# United States Department of the Interior

Re: Cottonwood Mine Resource Recovery and Protection Plan  
(R2P2), 9th Left Longwall Panel

On June 22, 1992, the Bureau of Land Management (BLM) received PacifiCorp's request to modify the approved R2P2 for the Cottonwood Mine as it applies to the 9th Left longwall panel. The affected reserves are located in the Hiawatha Seam on Federal coal leases SL-070645 and U-083066.

LOCATION OF SET-UP ROOMS

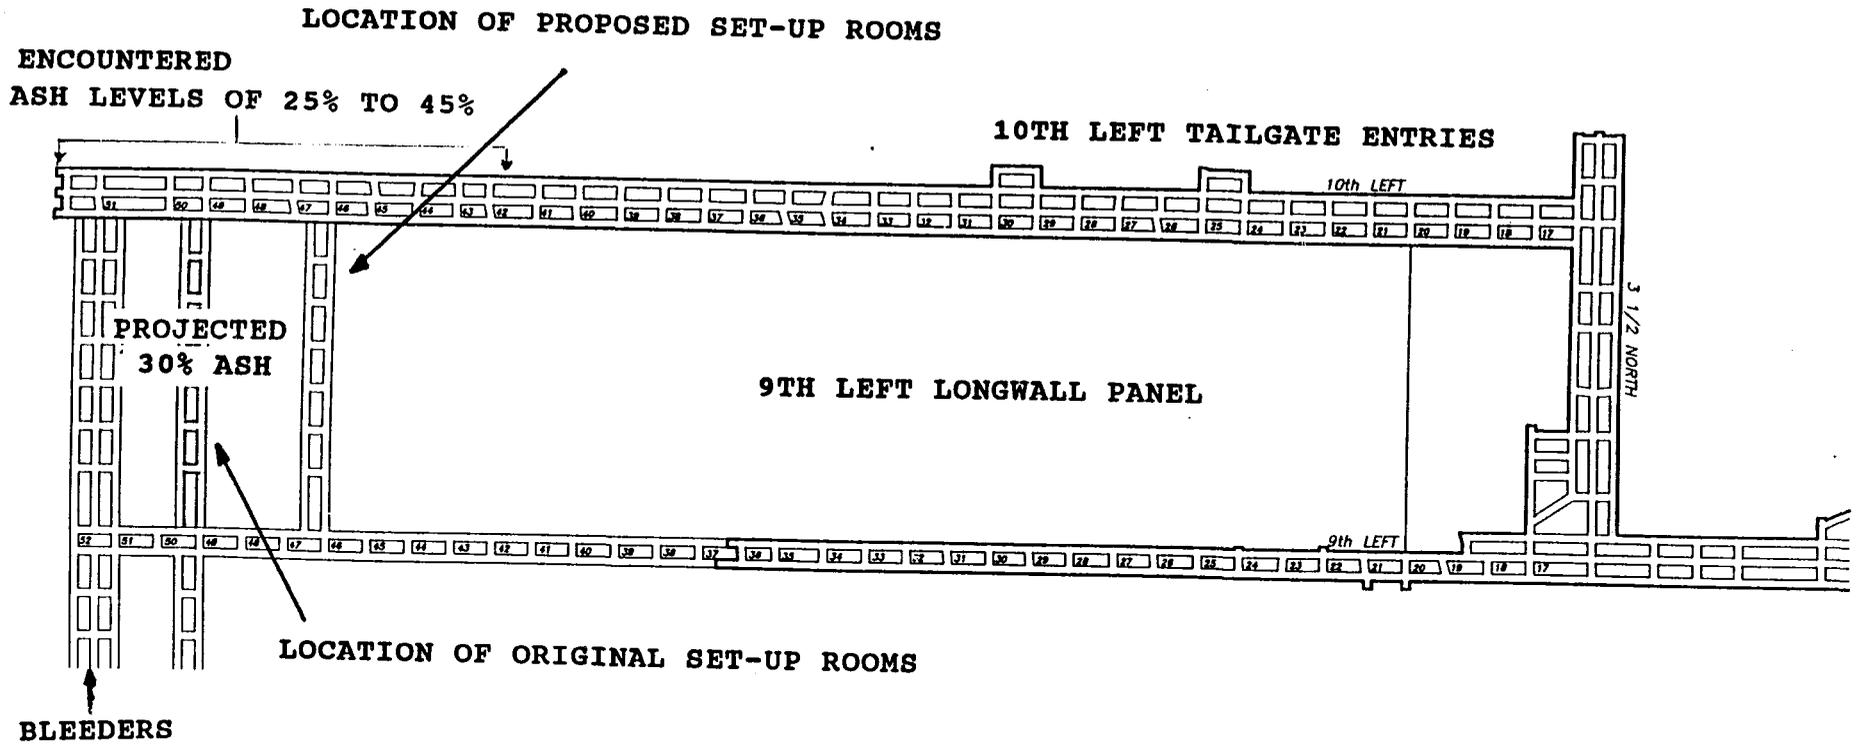
According to the approved R2P2 for the Cottonwood Mine, the 9th Left longwall panel's set-up rooms were to traverse the panel at crosscut 49. PacifiCorp's modification changes the approved R2P2 by relocating the set-up rooms to crosscut 46 (see Enclosure 1).

- 1) At crosscut 42 in the 10th Left Tailgate entries, a carbonaceous mudstone band becomes a more pronounced, hardened rock parting. Within 800 feet (from crosscuts 42 to 51), the rock parting has increased from 0.5 feet to 2.0 feet in thickness. From crosscut 42, it has been necessary not only to extract the coal seam, but also the mudstone rock parting and a rider seam. In these conditions, panel development has encountered mine ash levels ranging from 25 percent to 45 percent. However, from outby crosscut 46, PacifiCorp feels they can support the immediate roof during the longwall mining process.

2) Due to multiple-seam loading conditions, the 10th Left Tailgate rib-line for the 9th Left longwall panel has fractured the coal and rock parting from inby crosscut 46 to the bleeder connection. The Cottonwood Mine's extraction procedure for the 9th Left longwall panel is to get under and support the rock parting to minimize dilution. PacifiCorp surmises that because of the multiple-seam loading, supporting the rock parting to minimize dilution from inby crosscut 46 is not possible and will result in an ash level of 30 percent in the run-of-mine coal product.

3) Because of the existing limitations of PacifiCorp's wash plant, the coal to be produced from inby crosscut 46 cannot be processed into a product which PacifiCorp can blend to meet power plant specifications of less than 16 percent ash.

Three inspections were made by BLM engineers to verify the conditions of the 9th Left longwall panel. During these inspections, the changing lithology of the coal seam, the deterioration of the rib line inby crosscut 46, and reports of high ash were confirmed.

To evaluate the possibility of multiple-seam loading conditions, overlays of the Deer Creek Mine were compared with the Cottonwood Mine maps. It was found that the 9th Left longwall panel area of the Deer Creek mine was not superimposed on the Cottonwood Mine. This condition is most likely contributory to the deteriorating rib line and creates a high probability that multiple-seam loading will prevent the supporting of the immediate roof inby crosscut 46 during the first 300 feet of advance on the 9th Left panel. Not being able to support the immediate roof, dilution of the coal will occur and an ash content of at least 30 percent will result.

To evaluate the logistics of blending, BLM engineers calculated the quantity of coal (with less than 12 percent ash) required to blend with the projected production from the 9th Left panel containing 30 percent ash. The calculations reflect that a 2:1 ratio is required to produce a product compatible with the power plant. With respect to the current production rates of the Cottonwood and Deer Creek Mines, this cannot be achieved.

The BLM has determined that the proposed modification does comply with the Mineral Leasing Act of 1920, as amended, the regulations at 43 CFR 3480, the lease terms and stipulations, and will achieve maximum economic recovery of the Federal coal. Therefore, the proposed modification is approved. By relocating the set-up rooms outby 300 feet, a reduction to the recoverable reserves base will occur. Approximately 56,500 tons on Federal coal lease SL-070645 and 18,500 tons on Federal coal lease

**ENCLOSURE 2  
APPROVED MINE MAP**

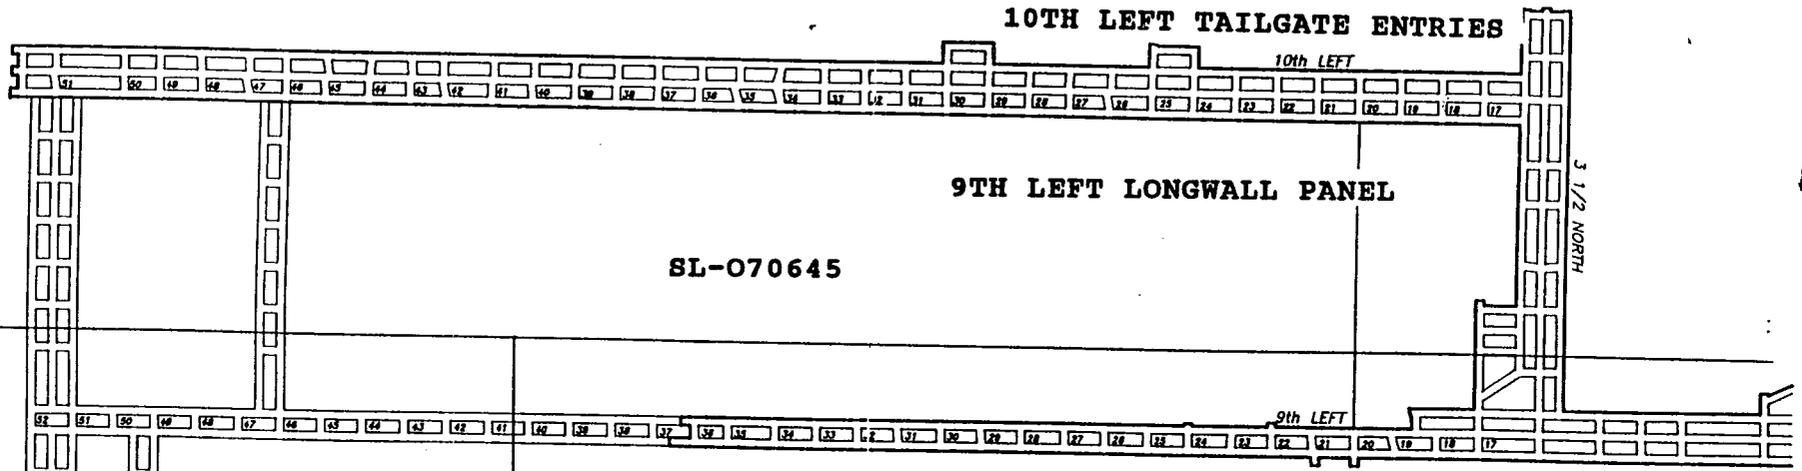
U-083066 are estimated. A copy of the approved mine map is enclosed (Enclosure 2).

**MINOR MODIFICATION TO  
MINING PLAN APPROVED BY  
BUREAU OF LAND MANAGEMENT**
